REPORT

14th meeting of GRRF Informal Working Group on Automatically Commanded Steering Function

Venue: TÜV-Rheinland in Köln, Germany
Chairman: Mr. Hiroshi Morimoto (J) and Mr. Christian Theis (D)
Secretariat: Mr. Jochen Schaefer (CLEPA)
Dates: 30. August – 1. September 2017
Website: [ACSF 14th session](#)

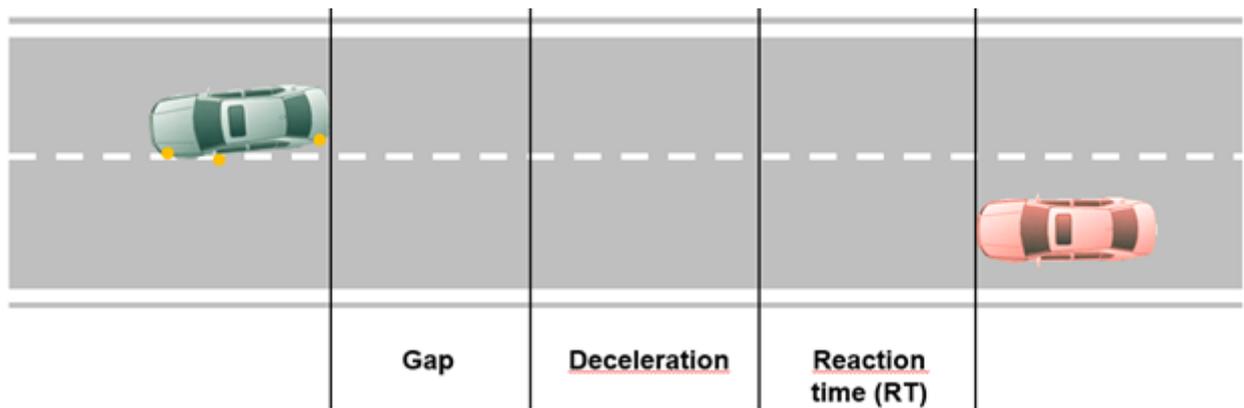
It started a lengthy discussion with regard to the values for

- reaction time/distance,
- deceleration distance and
- remaining distance (gap) between the vehicles.

the graph should show these parameters:
